**CITY OF SAINT PAUL  
HERITAGE PRESERVATION COMMISSION STAFF REPORT**

FILE NAME: 662 Conway Street  
INVENTORY NUMBER: RA-SPC-2427  
DATE OF APPLICATION: March 9, 2018  
APPLICANT: Kristen Sachwitz, All Energy Solar  
OWNER: Erik Berger  
DATE OF HEARING: April 12, 2018  
HPC SITE/DISTRICT: Dayton's Bluff Heritage Preservation District  
PERIOD OF SIGNIFICANCE: 1857-1930  
CATEGORY: Building Permit                      WARD: 7                      DISTRICT COUNCIL: 4  
CLASSIFICATION: Contributing  
STAFF INVESTIGATION AND REPORT: Allison Suhan  
DATE: April 5, 2018

The applicant proposes to install two solar panel arrays consisting of 5 panels each (10 total panels) on the southwest elevation roof. Array 1 is sited at the front half of the roof plane while Array 2 is sited in the back half behind the dormer and chimney. Electrical equipment for the panels is proposed to be installed on the southwest elevation towards the rear of the property.

ELECTRICAL PLAN

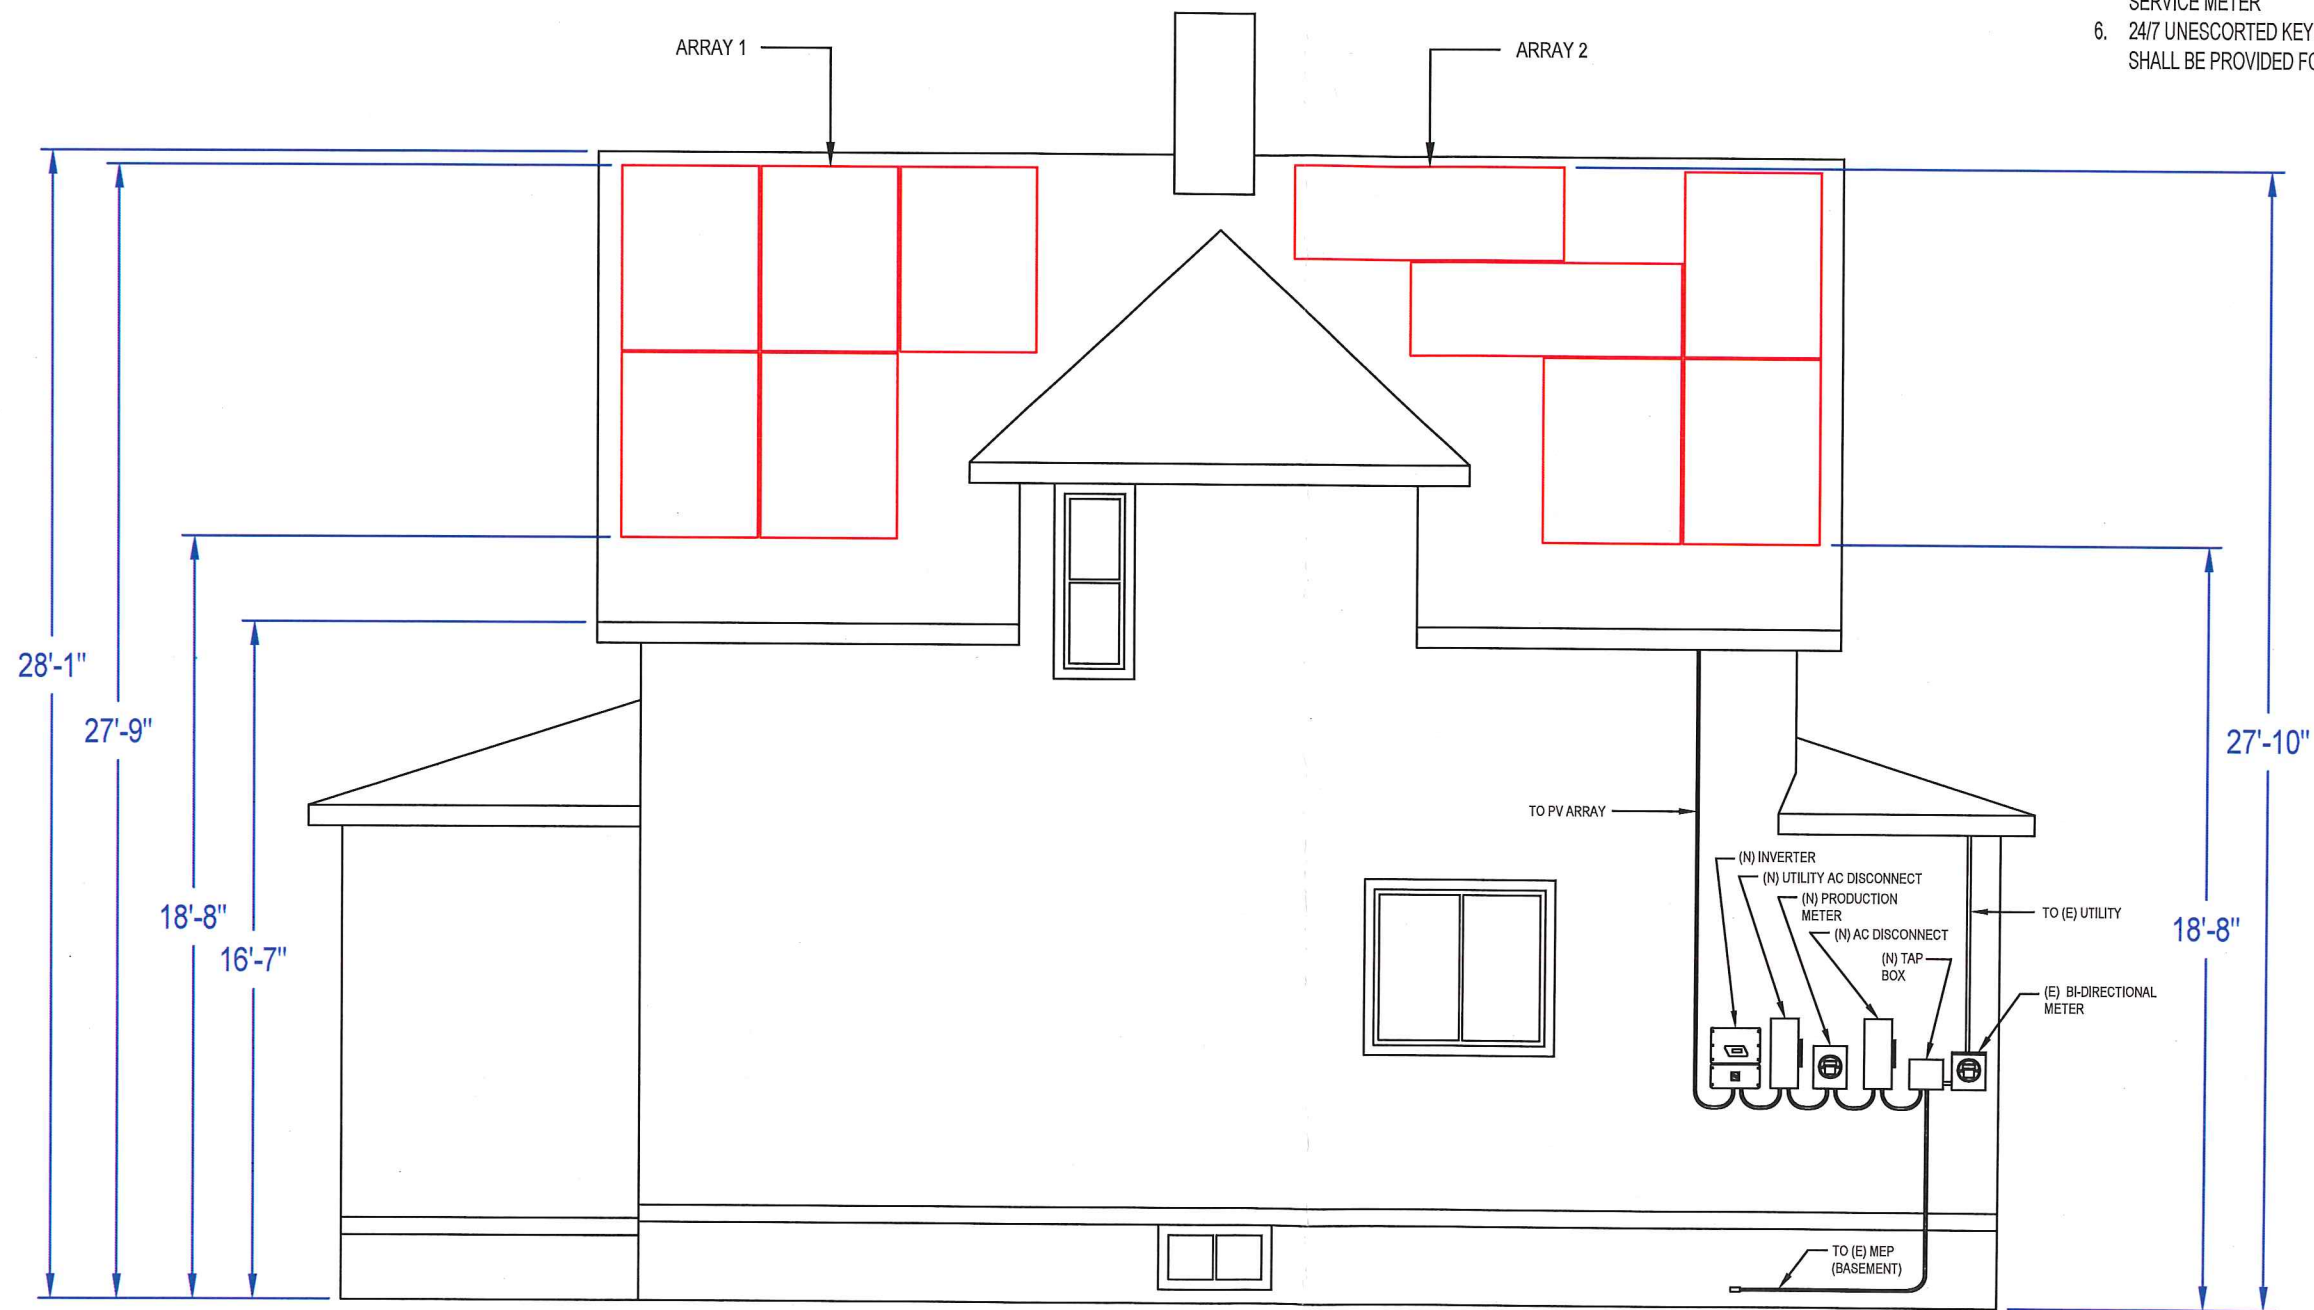
Citation	Meets Preservation Program	Comments
(d)(1) <i>Roof hardware such as skylights, vents and metal pipe chimneys should not be placed on the front roof plane.</i>	NO	Solar Array 1 is proposed on the front half of the roof plane.

16. **Sec. 74.90(d)(1)** *Roof hardware such as skylights, vents and metal pipe chimneys should not be placed on the front roof plane*. Solar Array 1 is proposed on the front half of the roof plane, thus it does not meet the guideline.

Staff can administratively approve solar installations behind the mid-point of the structure. As proposed, the system would be highly visible and would need Commission review.

**E. STAFF RECOMMENDATIONS:** Based on the findings, staff recommends denial of the building permit as proposed.

## BUILDING ELEVATION (SW SIDE VIEW)

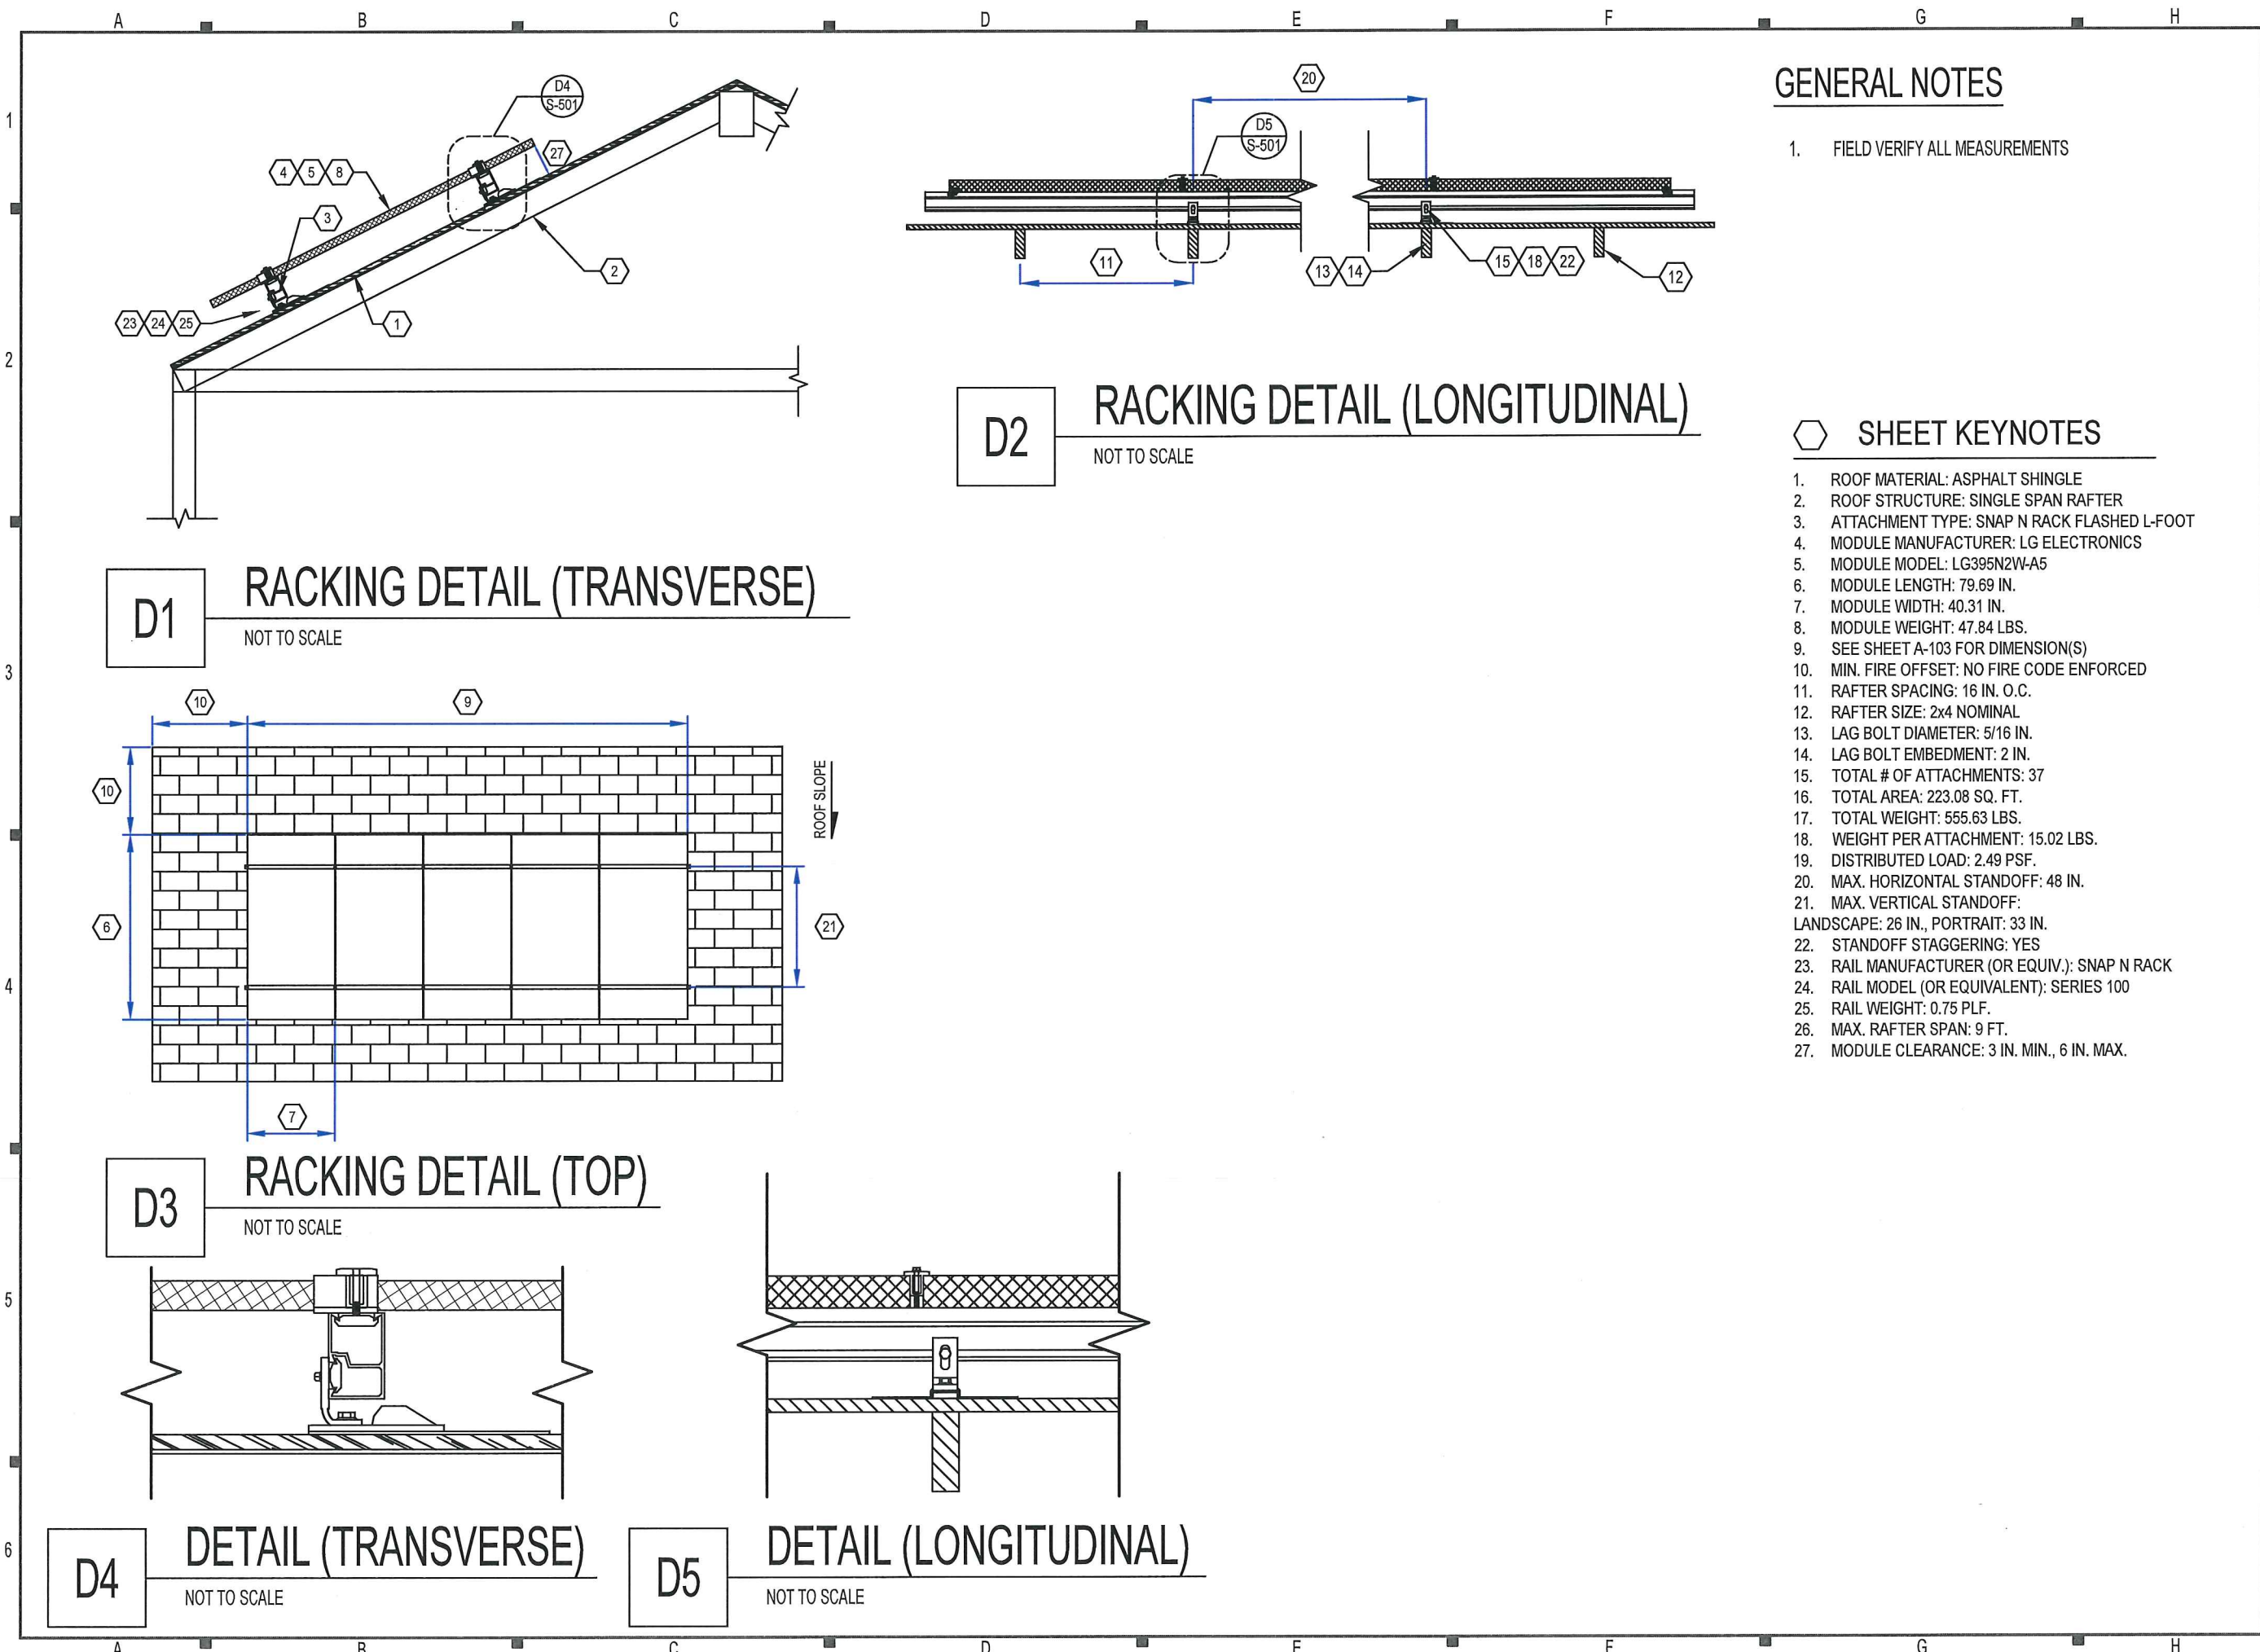
(5) <i>The impact of alterations or additions on individual buildings as well as on the surrounding streetscape will be considered; major alterations to buildings which occupy a corner lot or are otherwise prominently sited should be avoided.</i>	NO	Solar Array 1 will have a visual impact on the surrounding streetscape as it is highly visible from the public right of way.
--	----	--

*way: for example, on a flat roof and set back to take advantage of a parapet or other roof feature to screen solar panels from view; or on a secondary slope of a roof, out of view from the public right of way. While solar array 2 meets this guideline because it is set back on the roof plane behind the dormer, solar array 1 does not meet this guideline as it impacts the site and is highly visible from the public right of way, thus it does not meet the guideline.*

15. **Sec. 74.87 (5)** *The impact of alterations or additions on individual buildings as well as on the surrounding streetscape will be considered; major alterations to buildings which occupy a corner lot or are otherwise prominently sited should be avoided*. Solar Array 1 will have a visual impact on the surrounding streetscape as it is highly visible from the public right of way, thus it does not meet the guideline.
